GARSTKA
443

PLANVIEW TO HEALTH BOARD

**TITLE V
 OFFICIAL INSPECTION FORM – NOT FOR VOLUNTARY ASSESSMENTS
 SUBSURFACE SEWAGE DISPOSAL SYSTEM FORM
 PART A
 CERTIFICATION**

Property Address: 443 Flat Hills Road
 Amherst MA
 Owner's Name: Garrett Garstka
 Owner's Address: same
 Date of Inspection: 06/07/2006

PROFILE OF SEPTIC SYSTEM

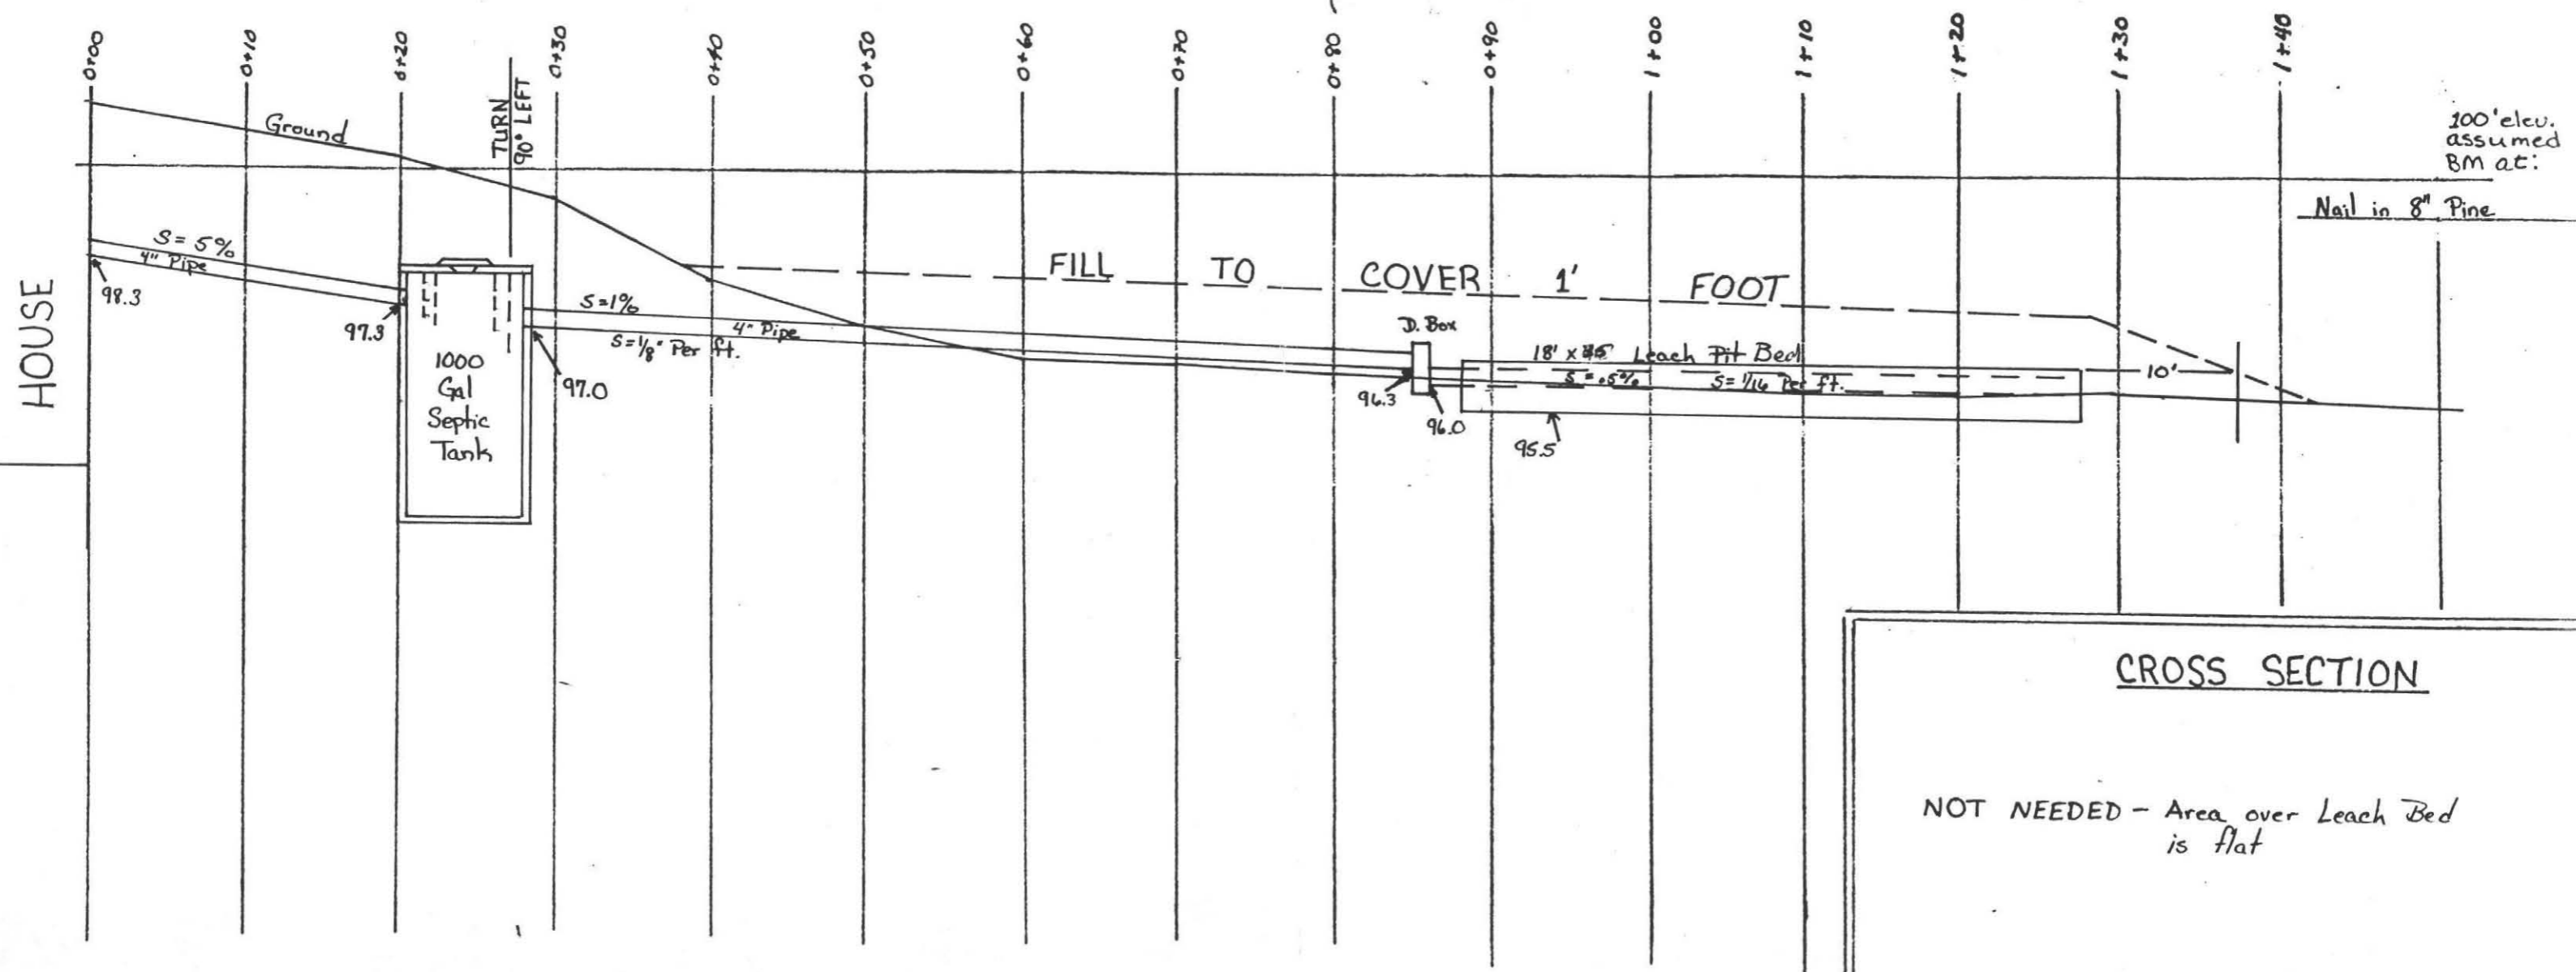
INSPECTED SYSTEM WITH FRED FILIOS
HE STATED SYSTEM WAS "ON" TO BACK FILL
WHEN (2 WEEKS LATER) HE SENT LETTER IT HAD
DIFFERENT ELEVATIONS) PIPE FROM TANK TO "D BOX"
WAS .83 NOT 1%. PAUL FILIOS CALLED
D.E.P. NO REQS REGARDING % FROM TANK
TO D BOX — I ASKED PAUL TO GET
IT IN WRITING

Fred Filios called - D.E.P. WILL NOT
SEND A LETTER (THERE IS NO REASON ELEVATION
(OF PIPE FROM TANK TO "D BOX"))
